**PETITION FOR CHANGE OF THE PROJECT DESCRIPTION IN THE FINAL
DECISION TO INSTALL AND OPERATE A SECOND LOAD COMMUTATOR
INVERTER (LCI) AND ASSOCIATED SWITCHGEAR
PALOMAR ENERGY CENTER
(O1-AFC-24C)**

**SAN DIEGO GAS & ELECTRIC COMPANY
SAN DIEGO, CALIFORNIA**

CALIFORNIA ENERGY COMMISSION

AUGUST 2010

JOB NUMBER	REV
120404	A
DRAWING NUMBER	ESK1-1

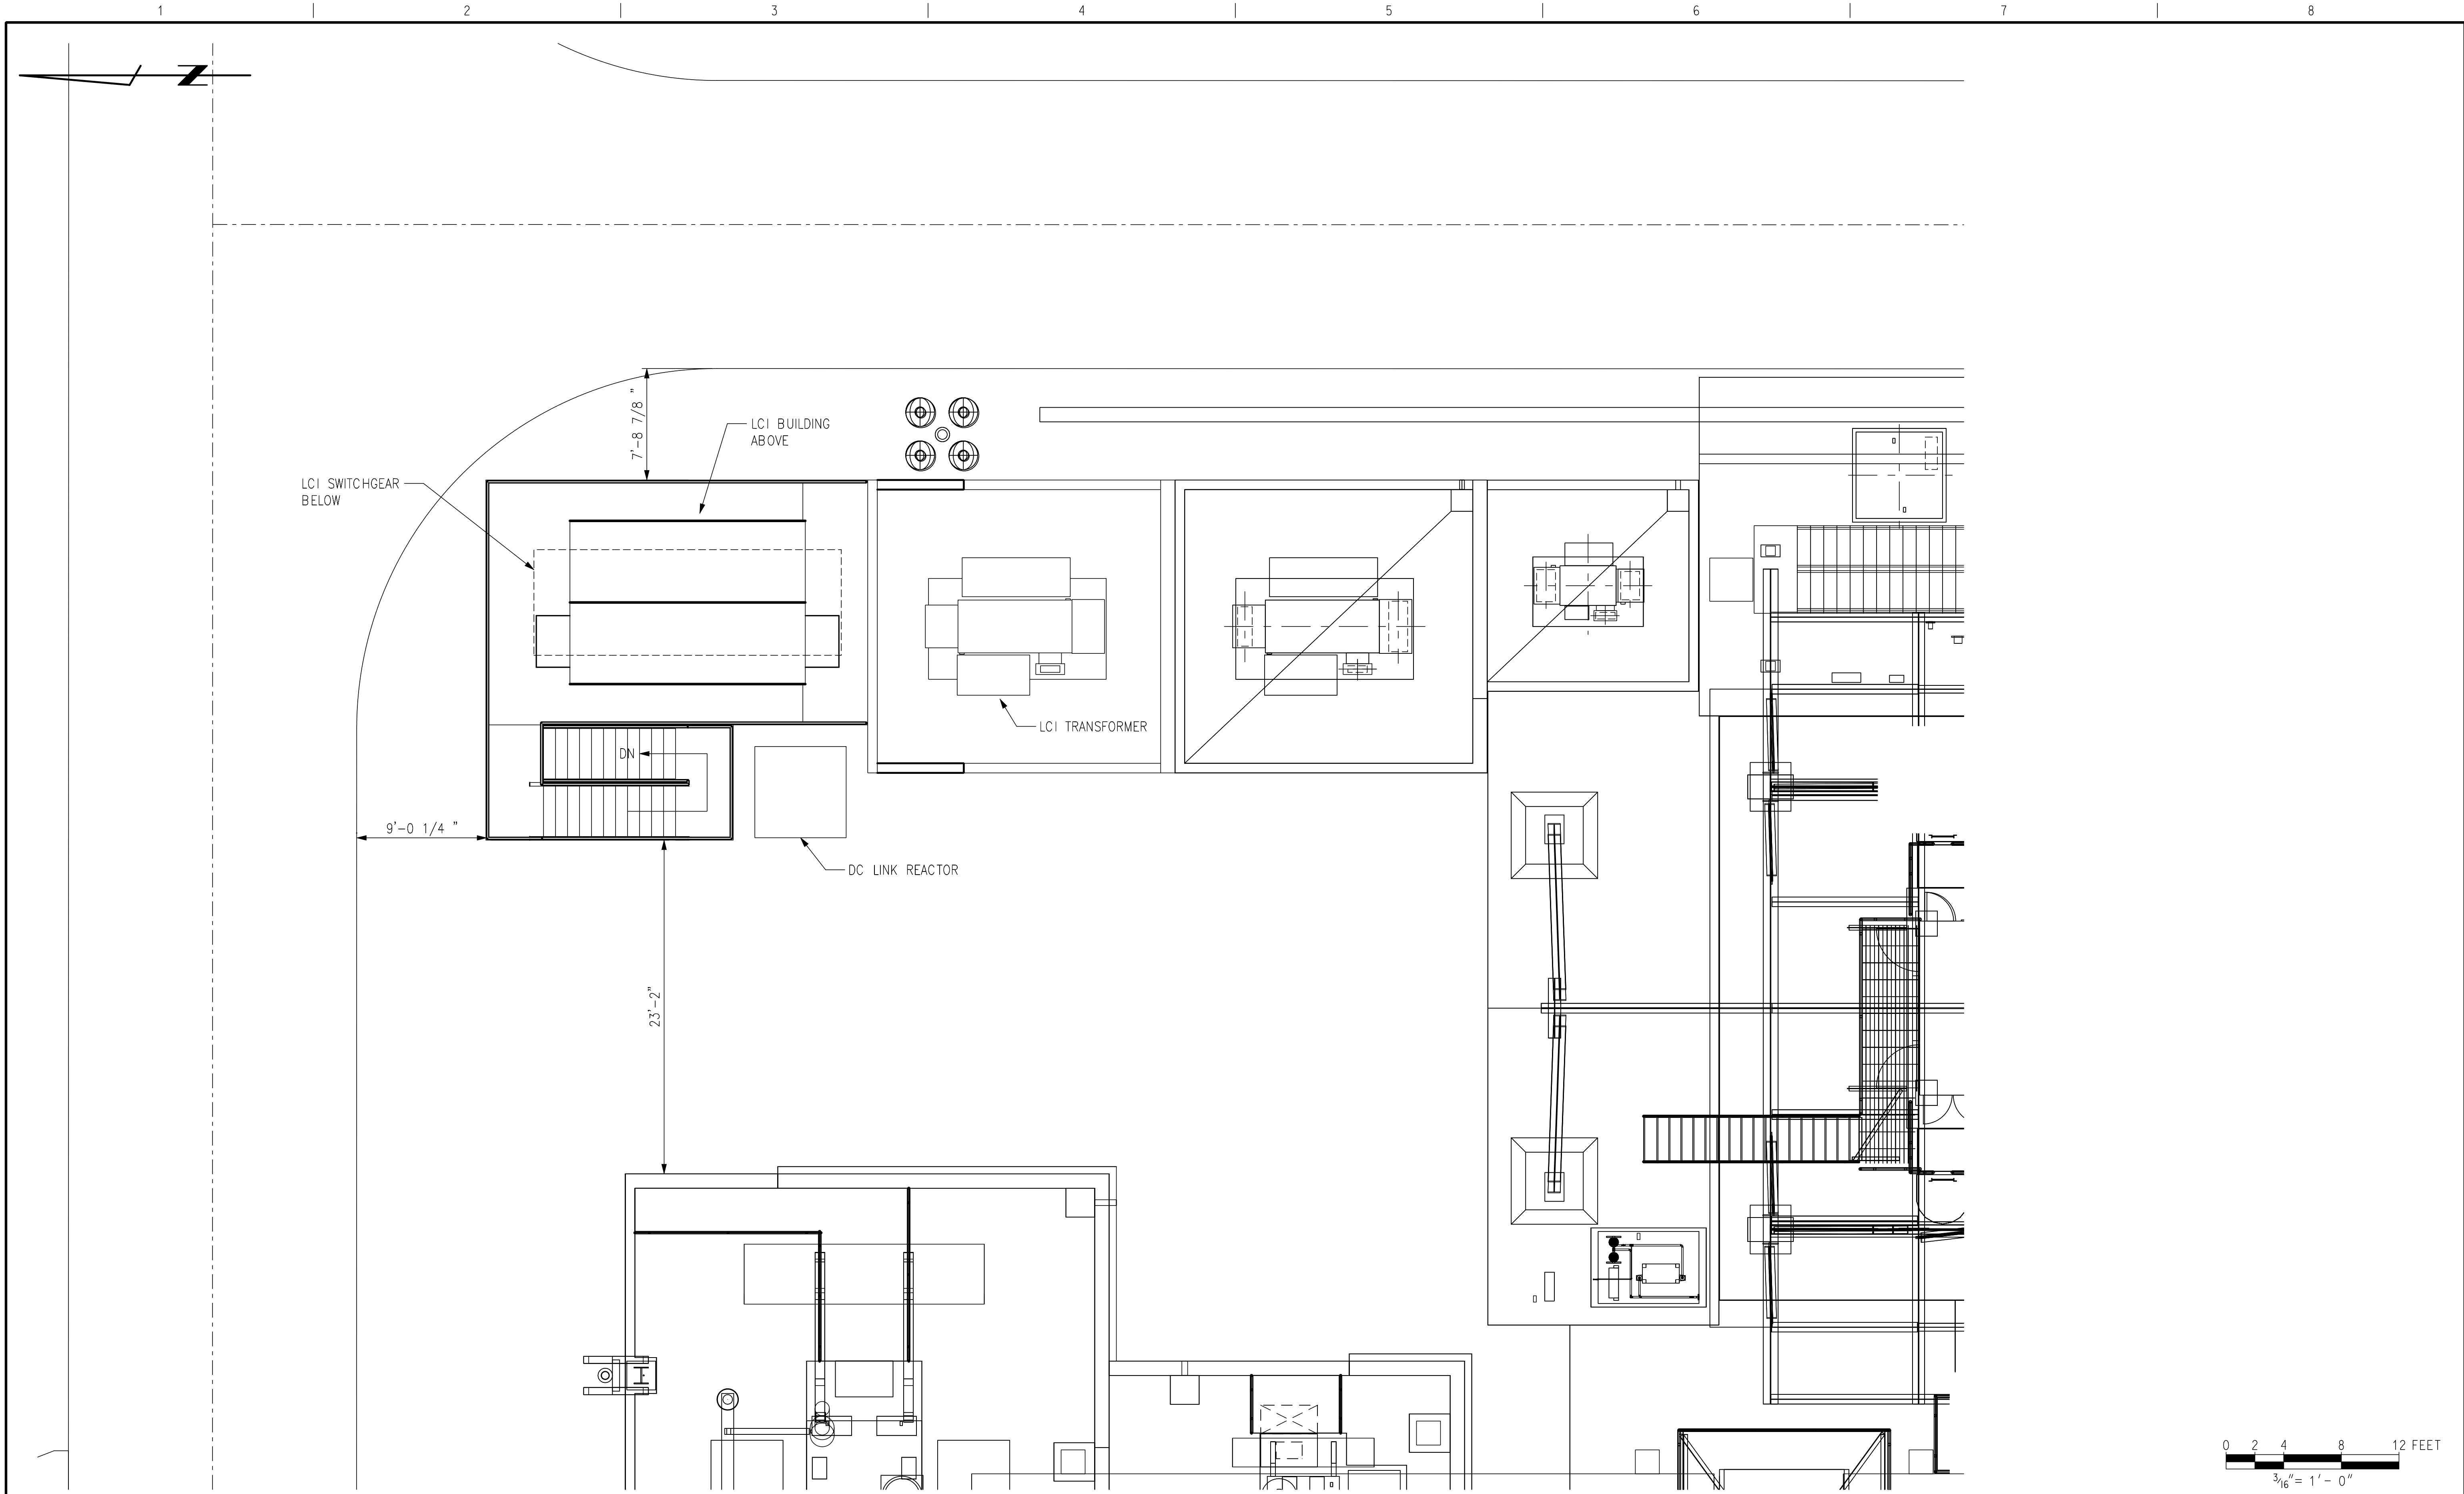
The new LCI transformer with foundation and containment will be located directly north of the existing LCI transformer. The new switchgear module will be located directly north of the new LCI transformer, to the east of the Unit 2 GSU. See Appendix 1 for a revised site plan showing the location of the new equipment. Space between the GSU and new equipment will be maintained for access to the generator and removal of the generator rotor for maintenance. The new LCI hardware will be installed in a small walk-in module built above the switchgear module. Stairs and platforms for the new LCI module are part of the project. Previous excavation, backfill and compaction took place during plant construction in the area where the new equipment is to be installed.

The new equipment will be painted the plant color (SW 1022 Cubist grey) and will not be visible from off site. Visual simulations are also attached in Appendix 1. The equipment will be stacked in two small enclosures, the largest of which will measure approximately 8 x 20 feet. The top of the new equipment will be approximately 25 feet high, lower than the adjacent air intake structures. None of the new equipment will generate noise. There are no hazardous chemicals associated with the new equipment. The new transformer will contain a small amount of transformer oil (no PCB's). The new
